RE: Agreement No. 1945F
Project Number T202369005
Traffic Impact Study Services
Task 17-11 Wawa Smyrna TIS

Johnson, Mirmiran, and Thompson (JMT) has completed a review of the Traffic Impact Study (TIS) for the Wawa Smyrna development which was prepared by Bowman Consulting Group, Ltd. dated March 14, 2024. This review was assigned as Task Number 17-11. The report is prepared in a manner generally consistent with DelDOT's *Development Coordination Manual* and other Department standards.

Recommendations Map

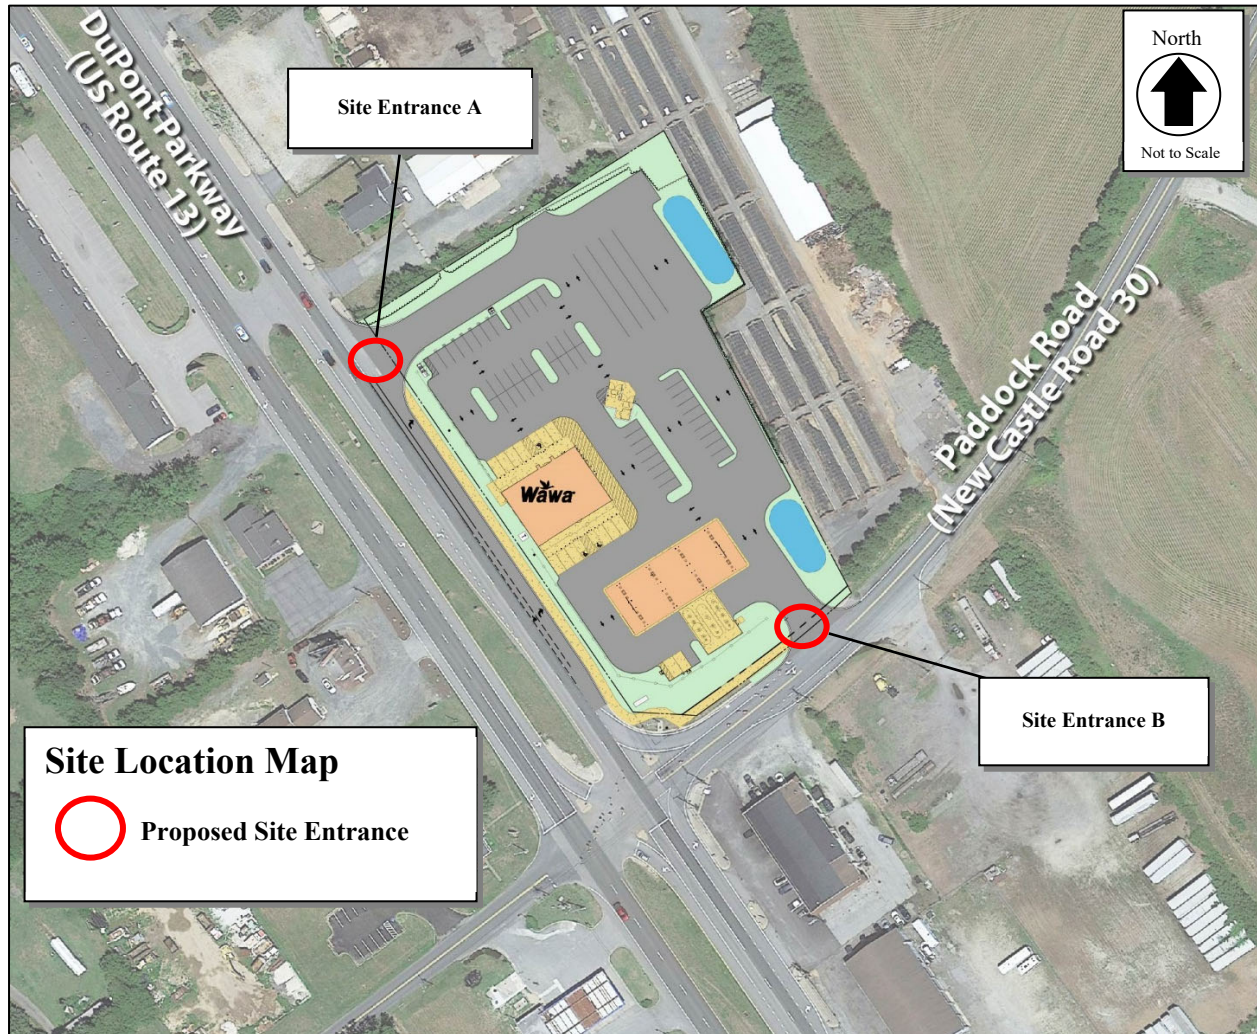
3. The developer should maintain the existing unsignalized Site Entrance A rights-in/rights-out only access for the Wawa Smyrna development along DuPont Parkway (US Route 13), approximately 355 feet north of Paddock Road. Based on DelDOT’s *Development Coordination Manual*, the recommended minimum storage length (excluding taper) of the northbound right turn lane is 410 feet. However, due to storage length limitations as a result of the distance between Site Entrance A and the Paddock Road intersection, a minimum storage length (excluding taper) of 300 feet is recommended. The projected queues from the HCS analysis can be accommodated within the recommended storage lengths.

4. The developer should reconstruct the existing unsignalized Site Entrance B, located approximately 200 feet east of the DuPont Parkway (US Route 13) intersection, to a rights-in/rights-out/lefts-in access only for the Wawa Smyrna development along Paddock Road. The existing bypass lane along Eastbound Paddock Road should be maintained. The intersection should be consistent with the lane configurations shown in the table below.

5. The developer should restripe the northbound US Route 13 right turn lane onto Paddock Road with a stop bar and remove the YIELD condition. The developer should submit a plan to DelDOT's Development Coordination Section depicting the design. The final design should be determined during the Entrance Plan review process.

7. The developer should modify the DuPont Parkway (US Route 13) median crossover approximately 270 feet north of Site Entrance A to only allow U-turn and left turn movements along DuPont Parkway (US Route 13). A concrete island should be installed at the median crossover to formalize the movements.

8. The developer should install a concrete curb between the northbound DuPont Parkway (US Route 13) through lane and left turn lane at the median crossover approximately 270 feet north of Site Entrance A to prevent motorists exiting Site Entrance A from accessing the median crossover. The concrete curb should start at the median crossover and extend past Site Entrance A.

- a. A minimum fifteen-foot-wide permanent easement from the edge of the right-of-way should be dedicated to DelDOT along the DuPont Parkway (US Route 13) and Paddock Road site frontages. Along the frontage, the developer should construct a ten-foot-wide shared use path (SUP). The SUP should be designed to meet current AASHTO and ADA standards. A minimum five-foot setback should be maintained from the edge of the pavement to the SUP/sidewalk. The developer should coordinate with DelDOT's Development Coordination Section during the plan review process to identify the exact location of the SUP.
